**Pacific Gas and  
Electric Company**

PG&E Letter DCL-00-071

License Amendment Request 00-02

Refueling Water Purification System Upgrade and Temporary Reverse Osmosis  
Skid Installation To Support RWST Cleanup During Power Operation

# RWST INTERFACE WITH TEMPORARY REVERSE OSMOSIS SYSTEM (ROS)

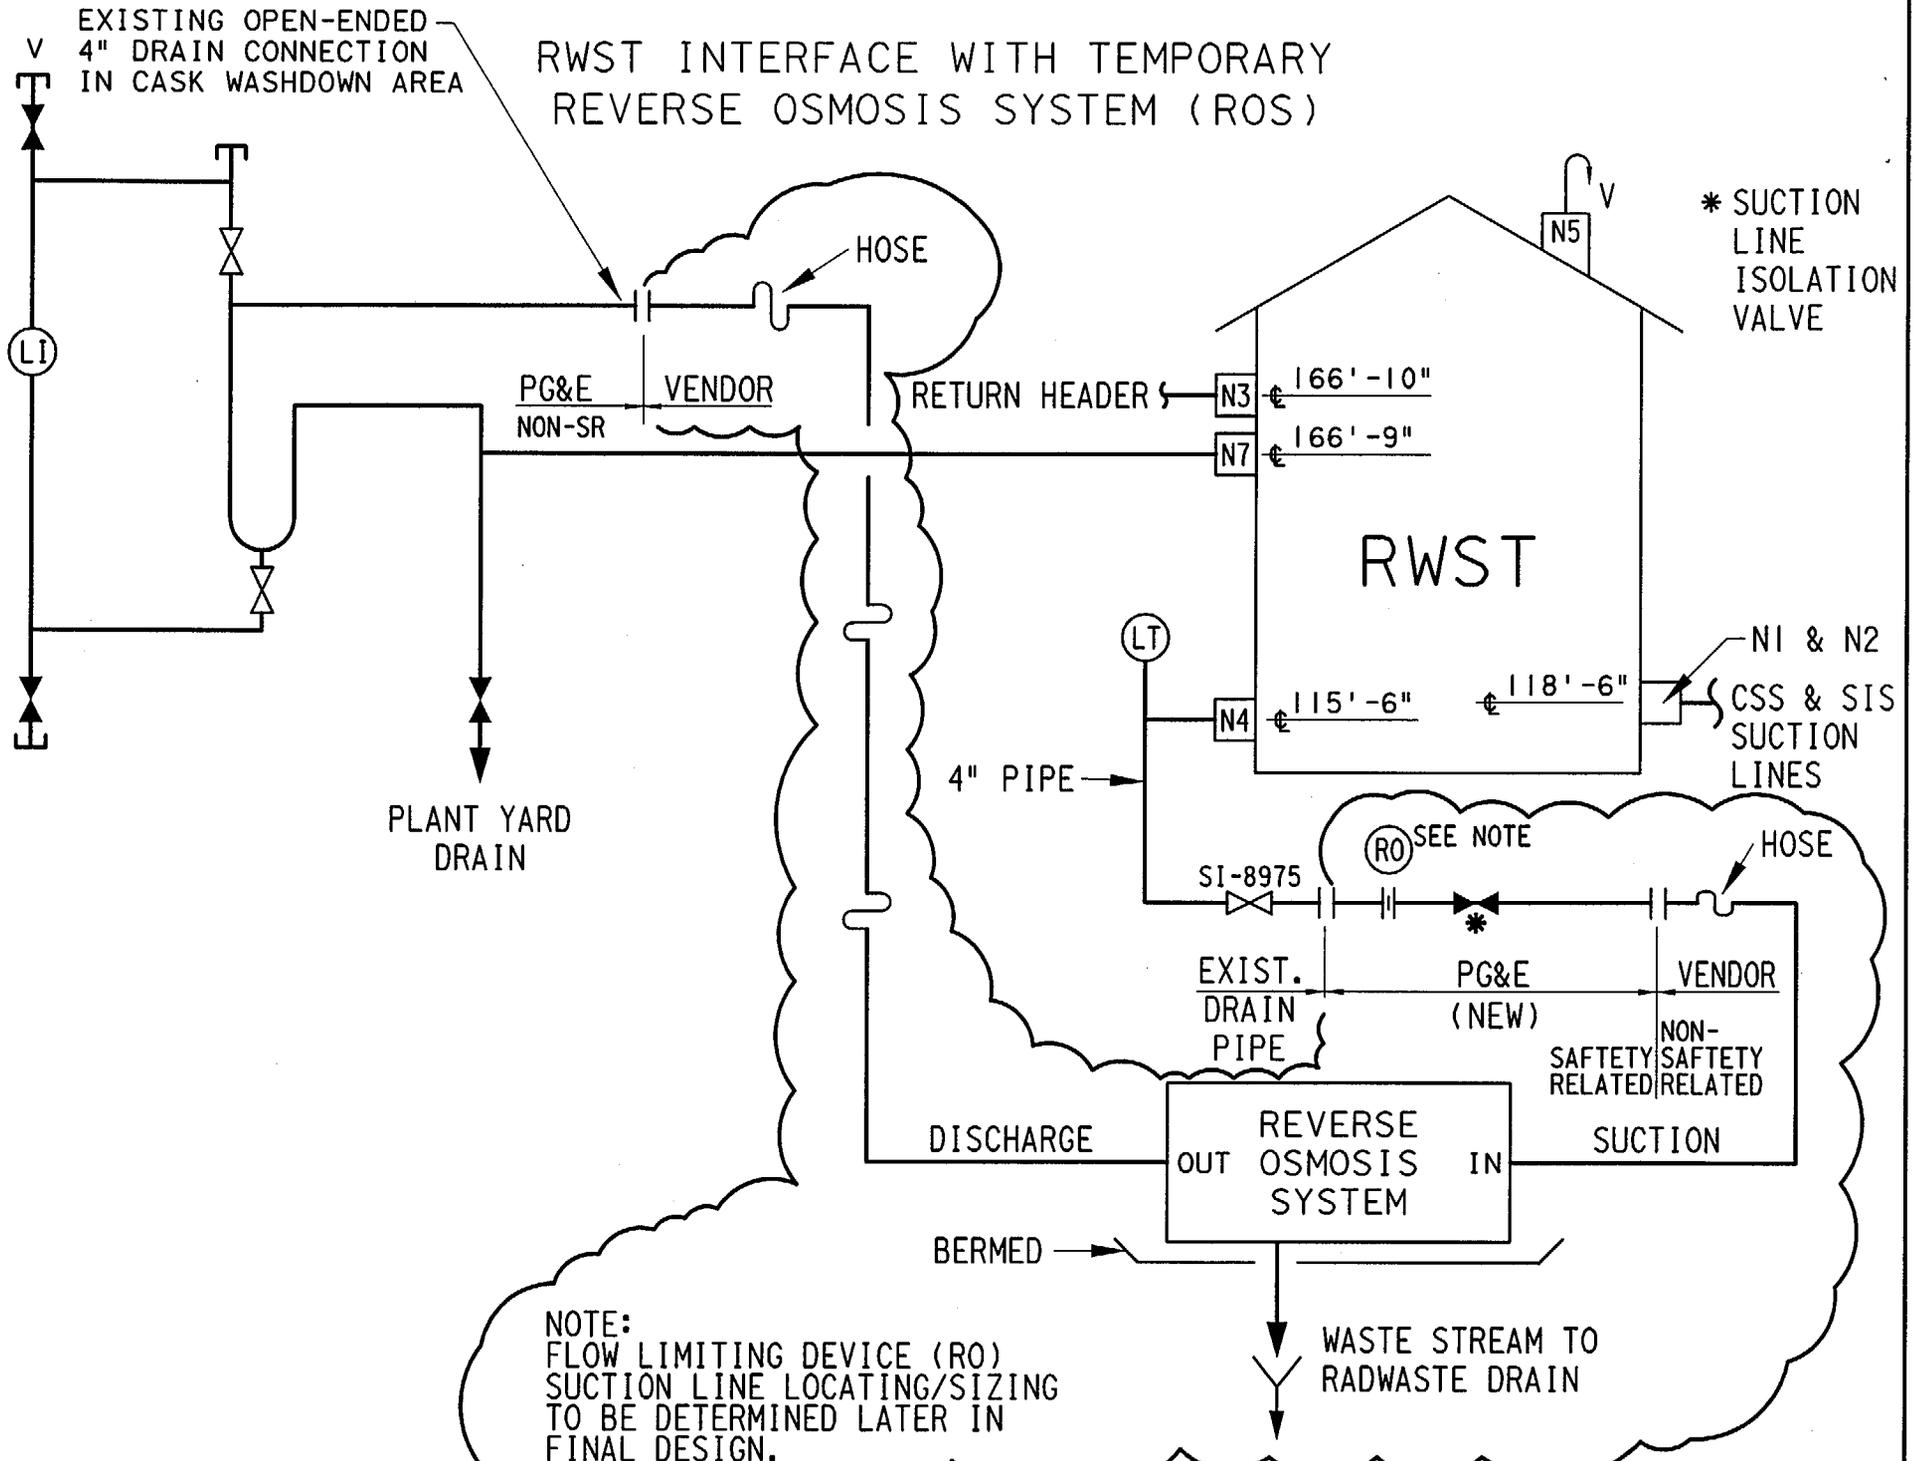
To support use of a RO system to reduce silica concentration in the RWST, a design change to the RWST piping will be made. A design class I passive flow limiting device will be added to the RWST drain piping connection. The flow limiting device will be sized to restrict the maximum leakage from the RWST inventory such that the minimum volume required by the RWST TS is maintained under maximum pressure drop conditions during a 1 hour operator action period required to isolate the RO system. The maximum RWST leakage flowrate allowable will be minimized and kept to that required to meet the RO system design capacity (currently a capacity of approximately 50-75 gpm). The RWST drain line which provides suction to the RO system does not provide flow to any safety-related equipment. In addition, a design class I manual isolation valve will be added upstream or downstream of the flow limiting device, such that the capability is available to isolate the design class I RWST piping from the non-design class I RO skid. All piping and valves will be designed or qualified to design class I/seismic category I up to the discharge of the flow limiting device or the isolation valve (if it is provided downstream of the flow limiting device). This will ensure RWST pressure boundary integrity during a seismic event.

NOTE:  
 FLOW LIMITING DEVICE (RO)  
 SUCTION LINE LOCATING/SIZING  
 TO BE DETERMINED LATER IN  
 FINAL DESIGN.

RWP SYSTEM UPGRADE:  
SIMPLIFIED DIAGRAM DEPICTING FLOW  
PATH WITH MAJOR EQUIPMENT SHOWN

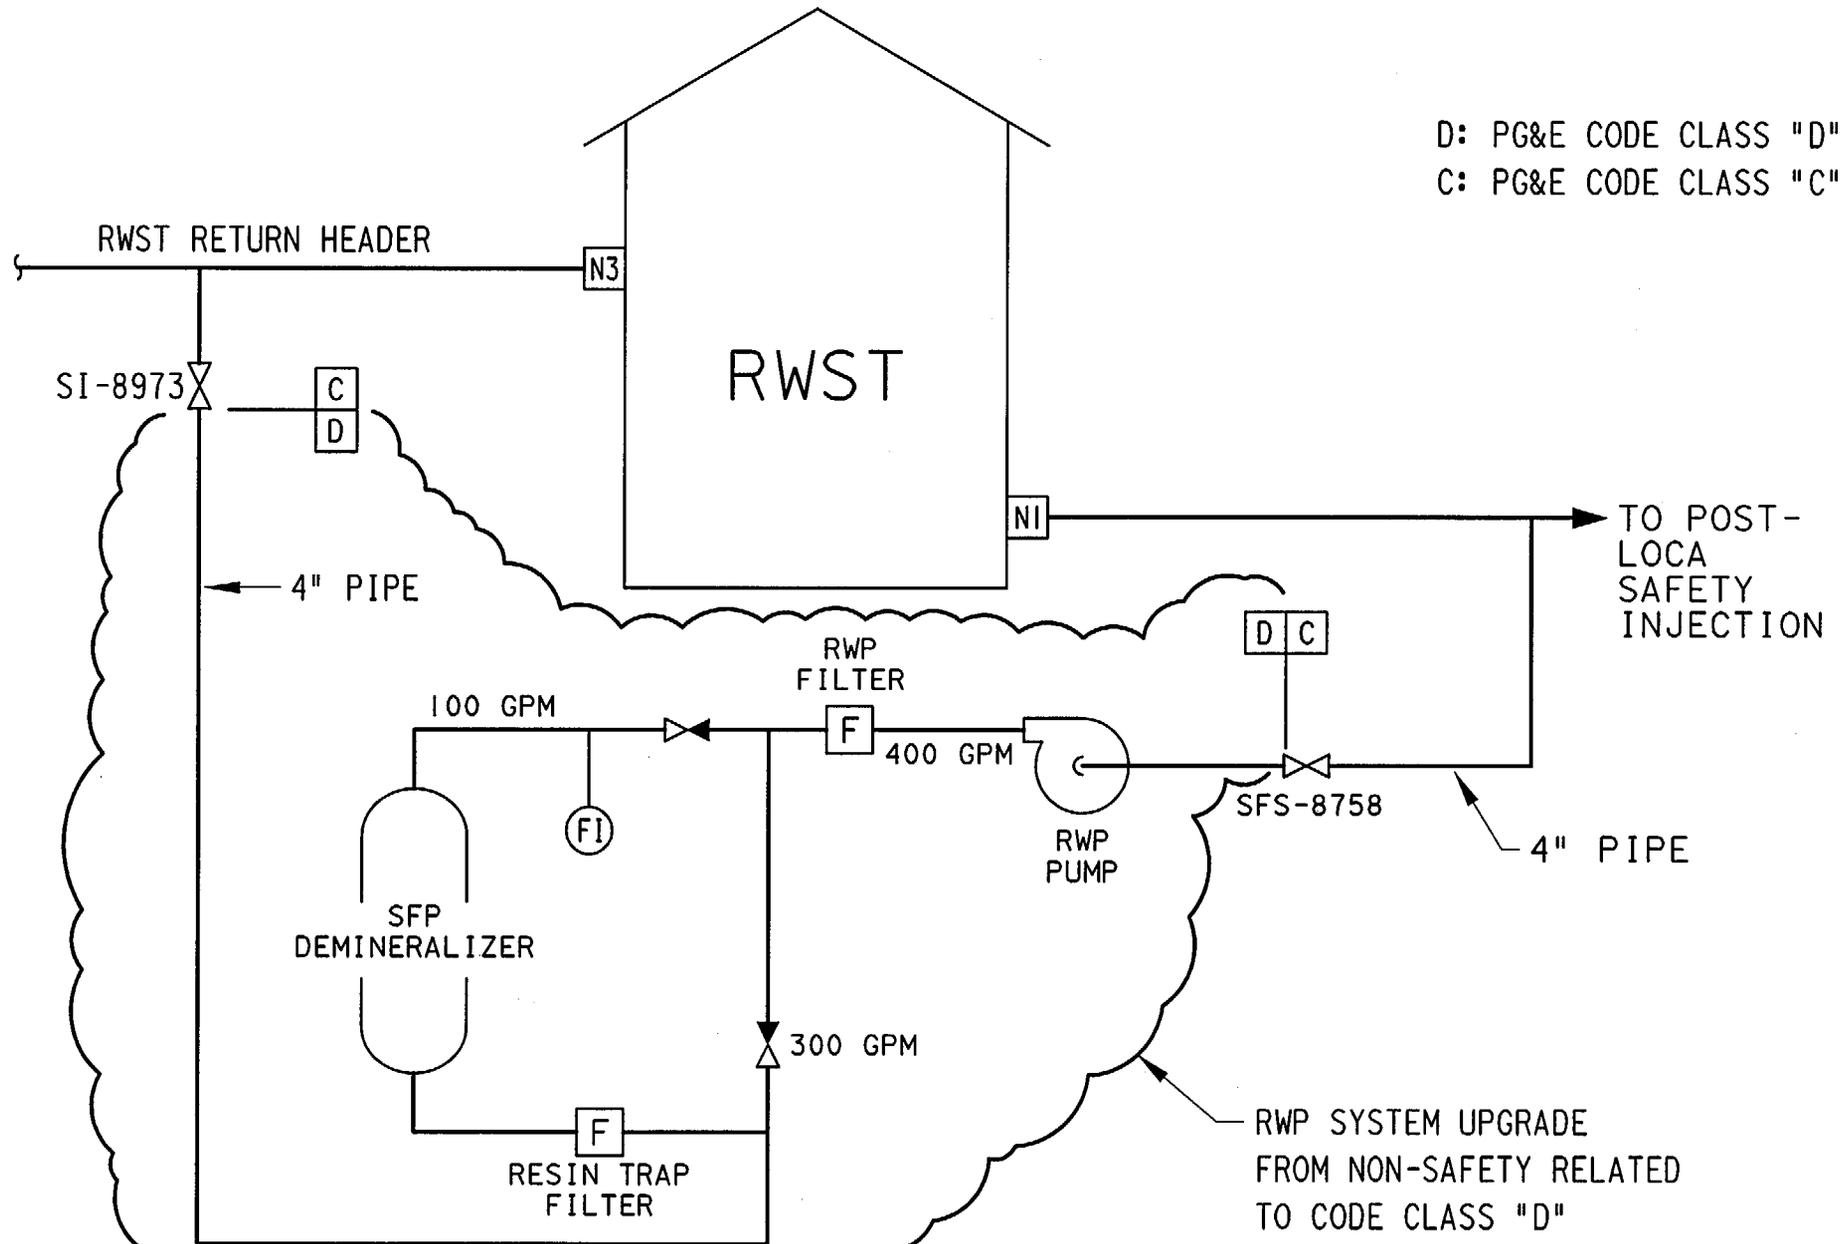
To allow processing of the RWST contents through the RWP system while the RWST is required to be operable, portions of the RWP system will be upgraded to meet the intent of a design class I/seismic category I piping system.

Upgrading the piping and components of the RWP system will provide reasonable assurance that the RWST pressure boundary is maintained when the two systems are interconnected. The upgrade will consist of a design change involving:

1. Seismically qualifying the RWP system to meet seismic category I criteria. This involves analyzing, modifying, or replacing RWP system piping and associated equipment, components, and supports as necessary.

2. System reclassification from design class II to design class I, PG&E piping code class "D". The original code of construction for the RWP system design, fabrication, and installation was ANSI B31.1.0-1967 (PG&E piping code class "E"). This reclassification will identify all components in the RWP system as PG&E piping code class "D". The PG&E piping code class "D" classification will impose the requirements that all future work on this system meet the requirements of design class I/seismic category I, quality class III (ANSI 18.2 safety class 3), similar to PG&E piping code class "C". The following activities define the minimum requirements for upgrading to PG&E piping code class "D" as defined in the Q-List:
